SECTION 131 FORM

Appeal NO: ACP APP-322154-25Defer Re O/H ☐Having considered the contents of the submission dated/ received 19/12/25

RE: An Coimisiún Pleanála - Case reference: PL10.322154. Planning Authority Case Reference: 2560003. Third Party response to letter received from An Coimisiún Pleanála in respect of a First Party appeal lodged in respect of the decision of Kilkenny County Council to refuse planning permission, under planning application Reg. Ref. 2560003 for ten year planning permission at a site situated in the townlands of Acragar, Ballyconra, Ballycuddihy, Ballyroe, Ballyroe (Grace), Ballyroe (Maher), Baunaniska, Boherkyle, Briskalagh, Brittas, Clone, Coolnapisha, Curraghduff, Freshford, Freshford Lots, Graigueswood, Grange, Huntstown, Kilmanagh, Knockeenglass, Knockown, Moatpark, Monabrika, Monavadaroe, Moneenaun, Oldtown, Oldtownhill, Parksgrove, Picketstown, Rathealy, Sart, Sweethill, Tobernapeastia, Tullaroan, Upperwood Demesne, Co. Kilkenny. The development will consist of the provision of the following: i. 7 no. wind turbines with an overall turbine tip height of 185 metres; a rotor blade diameter of 163 metres; and hub height of 103.5 metres, and associate

Fig. 5: Appellant's Fig. 2-2. Measured Vibration Levels at N1

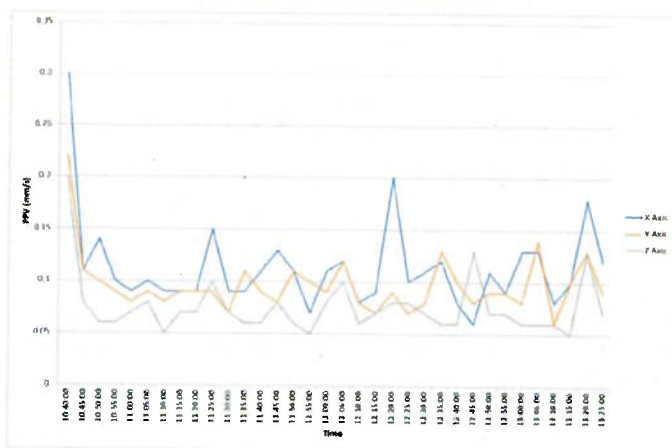
The potential for impacts on this SPA are identified in Section 4.1 of the updated NIS. The identified pathways for effect include: "Disturbance effects on populations of commuting and foraging kingfisher, associated with the SPA, in the vicinity of the Proposed Grid Connection underground cabling works beneath the River Nore". These concerns remain.

Fig. 6: Context stripped layout plan illustrations provided with the Further Information submission

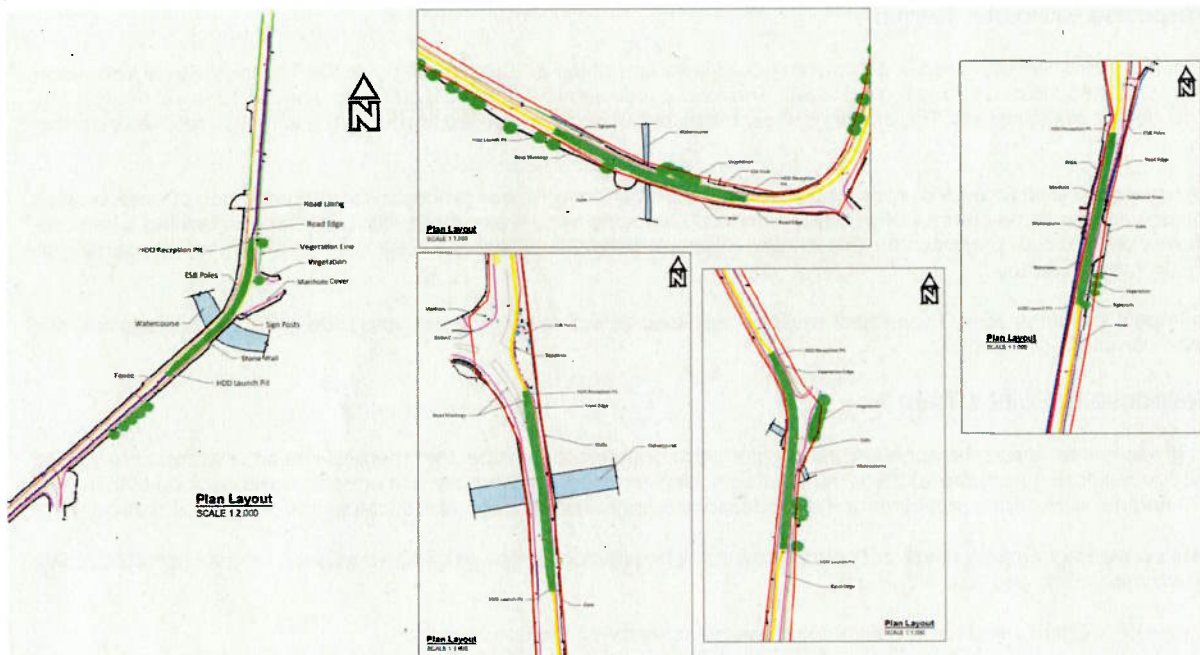
As the appellant offers such little detail, it is difficult to follow what is proposed by way of mitigation. It is certainly much as assessed by KCC.

Our client has read the appellant's covering submission and reviewed these drawings; they submit that the KCC decision should stand. The proposals would adversely impact the existing landscape, the river, the environment, and biodiversity at this location. The proposal has cumulative impacts not fully addressed by the appellant.

Fig. 7: Proposed riparian planting

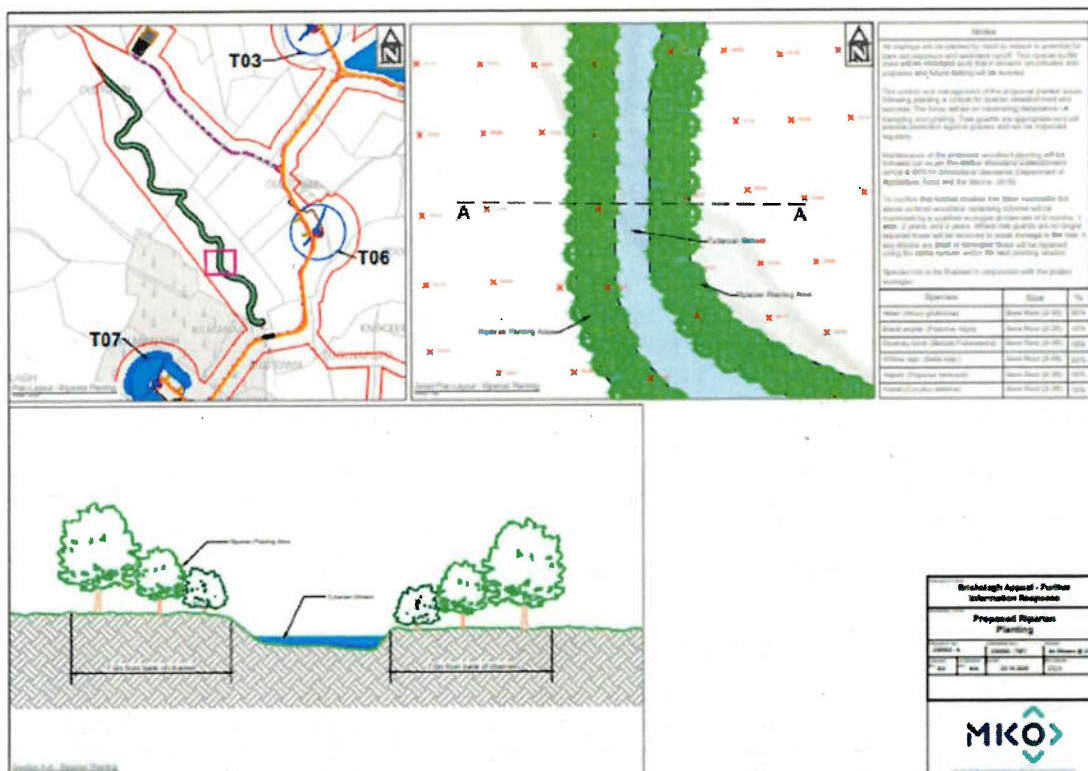
Our client has reviewed the submitted drawings and, again, considers that the landscape plan and section diagram details submitted are inadequate to fully illustrate and assess the likely impact of the proposed riparian buffer along the Tullaroan Stream (known locally as the Kilmanagh/Tullaroan River). They are concerned, as KCC has also expressed, with these proposals to interfere with the riparian environment at Kilmanagh/Tullaroan River.

Fig. 13: Photos of the tree to be removed as set out in the appellant covering submission (1)

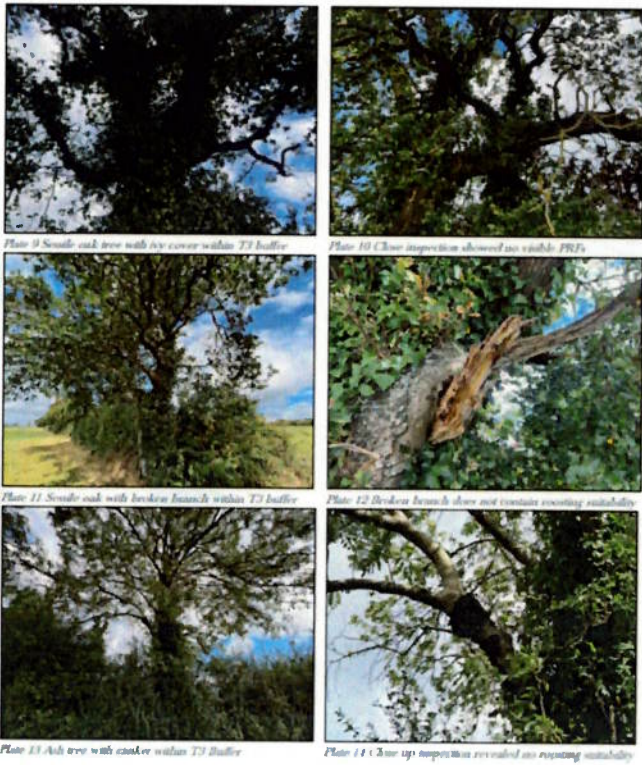
Again, the assessor is covered as to future findings which contradict the August 2025 survey as pre-commencement surveys are proposed to check again ("to ensure no bats are roosting in the structures and to safeguard compliance with relevant legislation")

This represents a lacuna in the survey effort. If roosting bats are identified during the pre-construction surveys, the appellant states that a derogation licence will be obtained from NPWS and mitigation measures will be prescribed by a licensed ecologist before works proceed. The appellant is asking the Commission to do the very thing this item sought to address.

Fig. 17: October 23, 2023 Flooding (Storm Babet)

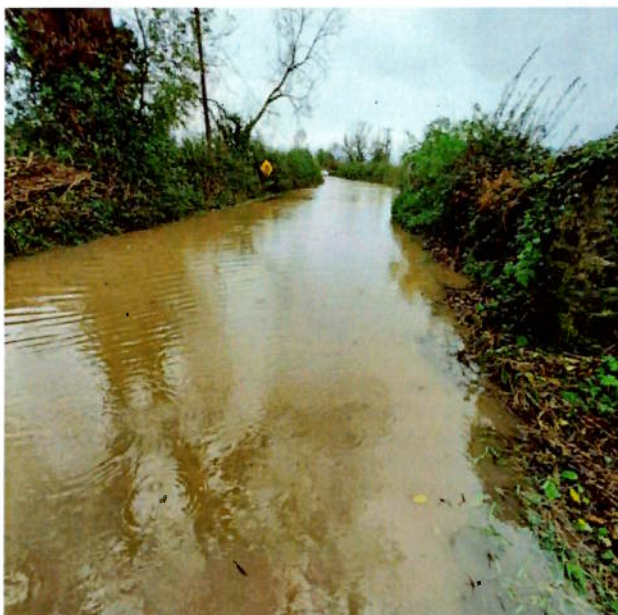
The hurling pitch at this location is known to be subject to flood inundation on a regular basis. Figure 1 below illustrates the hurling pitch following one of three flood events in October and November 2023. And as recently as 11th November 2025, flooding recurred at this location once again.

Fig. 30: Proposed Access Road from L5024 – appellant's FI stage submission

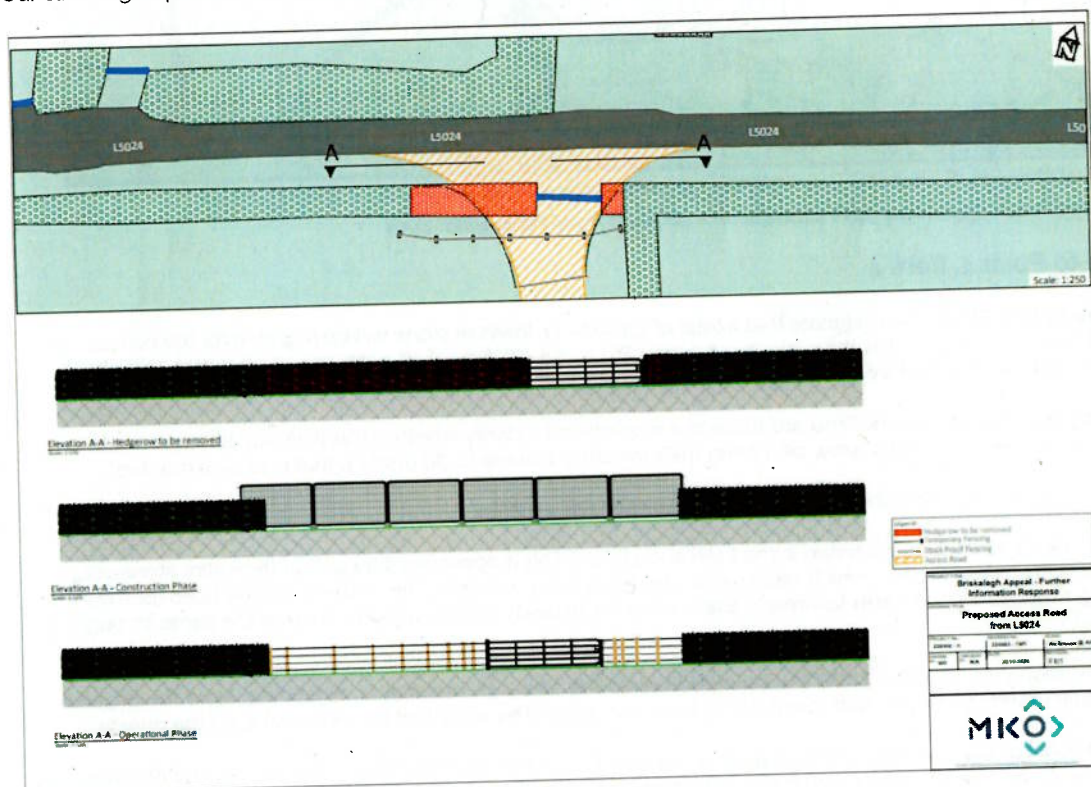
In reviewing the current FI response from the appellant, BPS expected to find the matter of the northern entrance fully addressed. The appellant has submitted Drawing 230502-79FI (see Appendix-2). This offers a proposed boundary treatment plan. However, the drawing lacks detail including:

Why does Fig. 30 not include sightlines or AutoTracking? The L5024 is a thin rural road. Can HGVs exit in an easterly or westerly direction without crossing into lands not owned or controlled by the appellant.

Our client's group submits that Fig. 30 raises more questions than it answers.
